**CITY OF EL PASO, TEXAS**  
**AGENDA ITEM DEPARTMENT HEAD'S SUMMARY FORM**

That the City expend additional available funding in the amount of SIXTY THOUSAND NINE HUNDRED NINE AND 80/100 (\$60,909.80) to VISTACON, INC. to fund additional labor and materials for Contract Number 2008-056, EPIA Terminal Modifications and Additional Public Concessions.

**CITY OF EL PASO ENGINEERING DEPARTMENT  
CONTRACT CHANGE ORDER**

### PROPOSAL REQUEST

DESIGNED BY	10/09/06
CHECKED BY	06/04
PROJECT NO.	FPI02
DATE	06/04
REVISED BY	
DATE	
PROJECT	PH-06
DRAWING NO.	SK4-FPI02

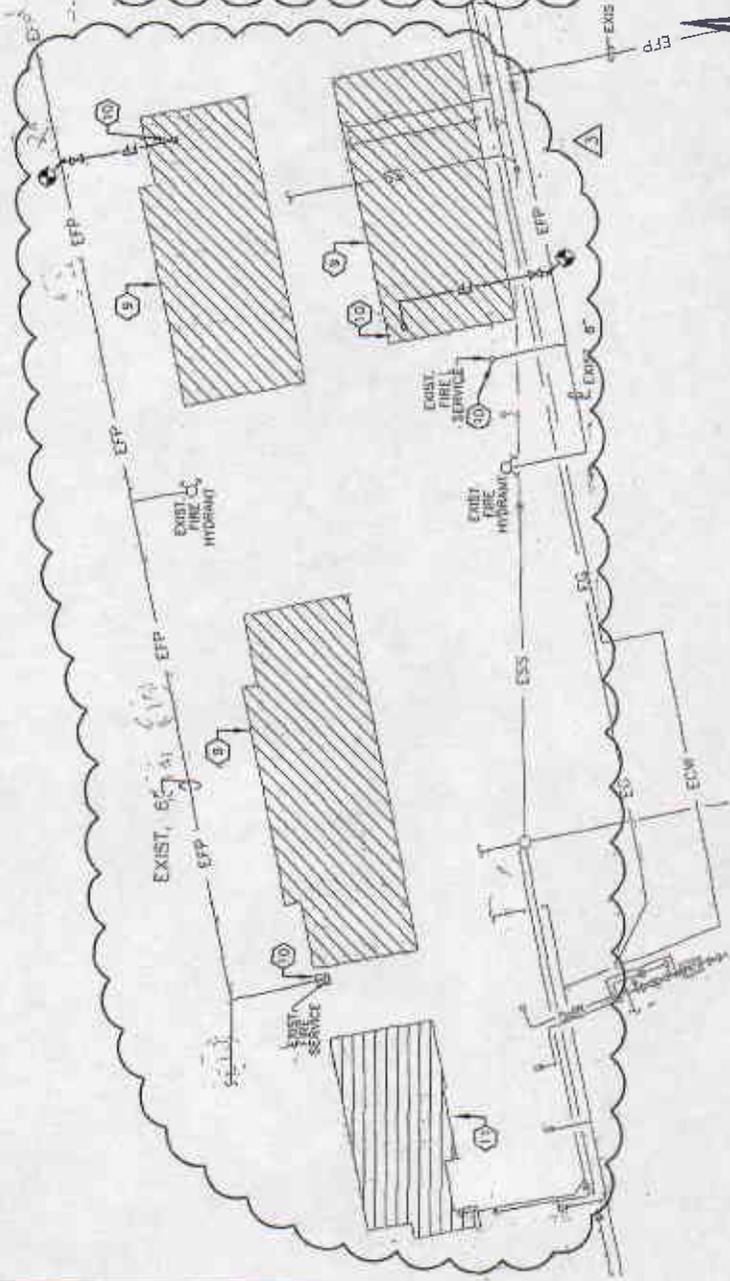
- 9 HATCHED AREA SHALL HAVE A DRY-PIPE FIRE SUPPRESSION SYSTEM. DRY PIPE SYSTEM SHALL PROVIDE COVERAGE FOR THE UNDERSIDE OF THE NEW UPPER LEVEL ADDITION WHERE EXPOSED. CONTRACTOR SHALL COORDINATE WITH ARCHITECT AND STRUCTURAL TO DETERMINE ROUTING OF SYSTEM PIPING WITHIN SOFFIT.
- 10 CONTRACTOR SHALL DETERMINE BEST SUITABLE LOCATION TO TAP DRY-PIPE SYSTEM INTO NEW OR EXISTING WET PIPE RISERS OR EXISTING DRY PIPE SYSTEM. FIELD VERIFY EXACT LOCATION OF EXISTING AND NEW FIRE RISERS AND EXISTING DRY PIPE SYSTEM. COORDINATE INSTALLATION OF RISERS WITH OTHER DISCIPLINES.
- 11 HATCHED AREA SHALL NO LONGER BE PART OF THE CONTRACT. WORK CONSISTED OF RELOCATING EXISTING SPRINKLERS AND PIPING TO MATCH NEW COVERAGE AREA AND CEILING GRID. CREDIT SHOULD BE GIVEN TO THE OWNER ON THIS WORK.

PARTIAL FIRST FLOOR -  
SPECIAL SYSTEM PLAN

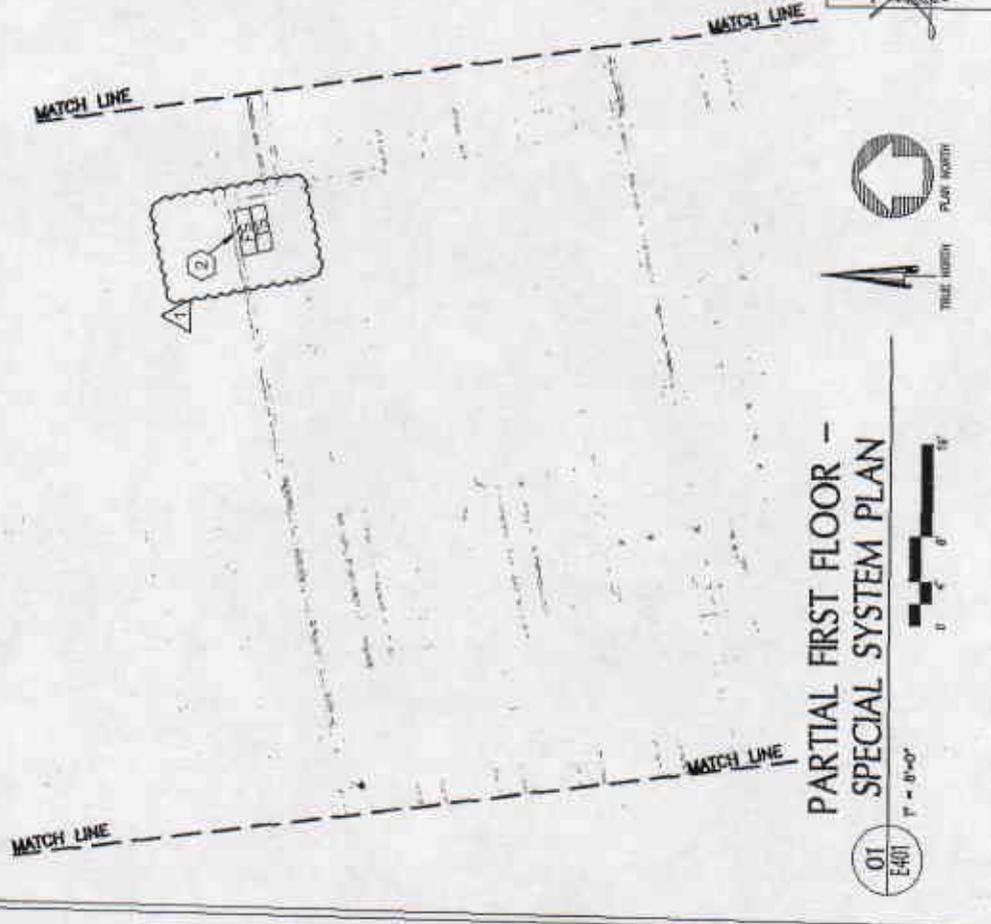
1. ELECTRICAL CONTRACTOR SHALL PROVIDE ALL NECESSARY ROUGH-IN FOR THE DRY-PIPE SYSTEM.

2. DRY-PIPE FIRE SUPPRESSION SYSTEM CONTROL PANEL, PROVIDE AND INSTALL BY FIRE PROTECTION CONTRACTOR. FIRE ALARM SHALL INTERFACE CONTROL PANEL WITH BUILDING FIRE ALARM SYSTEM. PROVIDE INTERCONNECTION CONDUIT AND WIRING TO VALVE COMPRESSOR, AND ALL ASSOCIATED DEVICES PER DRY-PIPE SUPPRESSION SYSTEM DRAWINGS. PROVIDE 120V EMERGENCY POWER TO CONTROL PANEL AND COMPRESSOR FROM NEAREST EMERGENCY PANEL WITH SPARE 20A/1P CIRCUIT BREAKERS. FURNISH AND INSTALL NEW 120V, 20A/1P CIRCUIT BREAKER IF SPARES ARE NOT AVAILABLE. USE 2#10, 1#100 IN 1/2".

PARTIAL FIRST FLOOR -  
SPECIAL SYSTEM PLAN

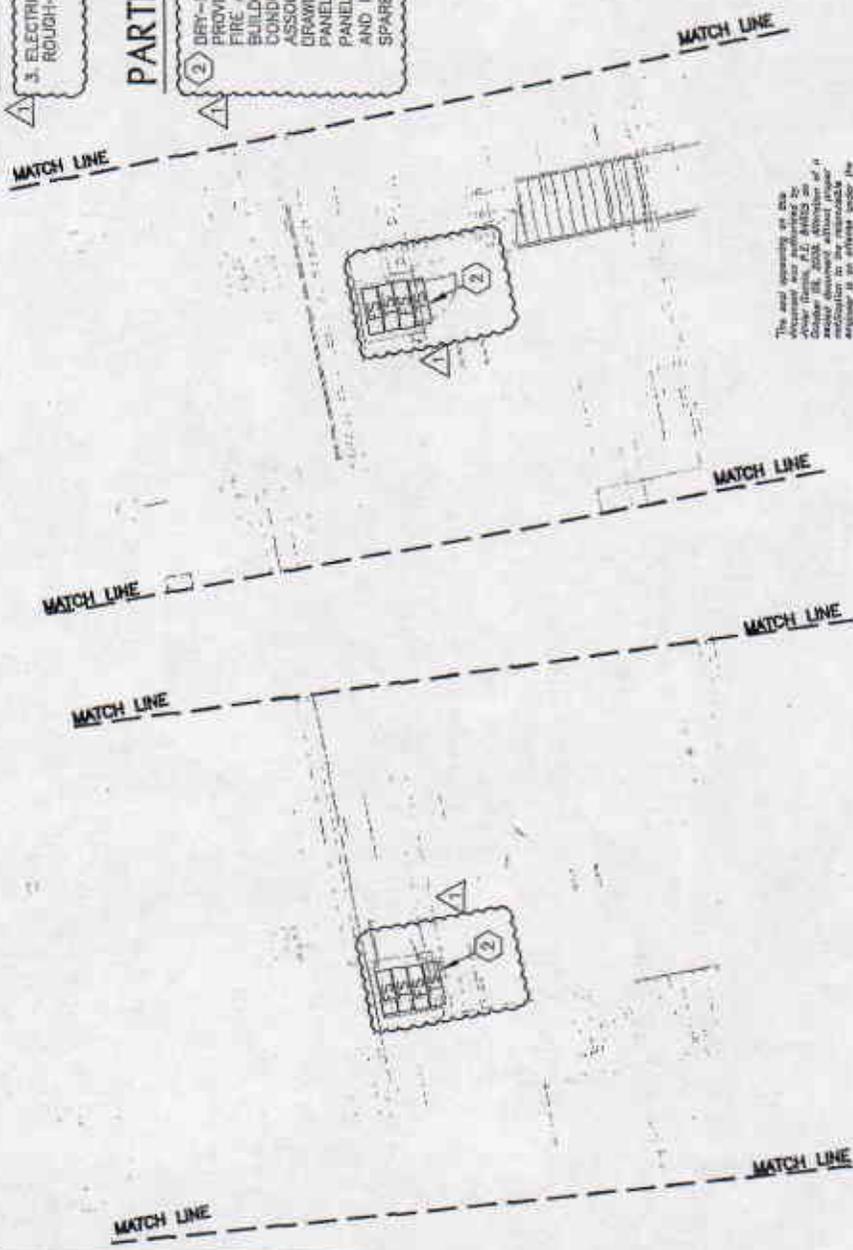
3. ELECTRICAL CONTRACTOR SHALL PROVIDE ALL NECESSARY ROUGH-IN FOR THE DRY-PIPE SYSTEM.

2. DRY-PIPE FIRE SUPPRESSION SYSTEM CONTROL PANEL PROVIDE AND INSTALL BY FIRE PROTECTION CONTRACTOR. FIRE ALARM SHALL INTERFACE CONTROL PANEL WITH BUILDING FIRE ALARM SYSTEM. PROVIDE INTERCONNECTION CONDUIT AND WIRING TO VALVE, COMPRESSOR, AND ALL ASSOCIATED DEVICES PER DRY-PIPE SUPPRESSION SYSTEM DRAWINGS. PROVIDE 120V EMERGENCY POWER TO CONTROL PANEL AND COMPRESSOR FROM NEAREST EMERGENCY PANEL WITH SPARE 20A/1P CIRCUIT BREAKERS. FURNISH AND INSTALL NEW 120V, 20A/1P CIRCUIT BREAKER IF SPARES ARE NOT AVAILABLE. USE #10, 1/2" LG IN 1/2" C.
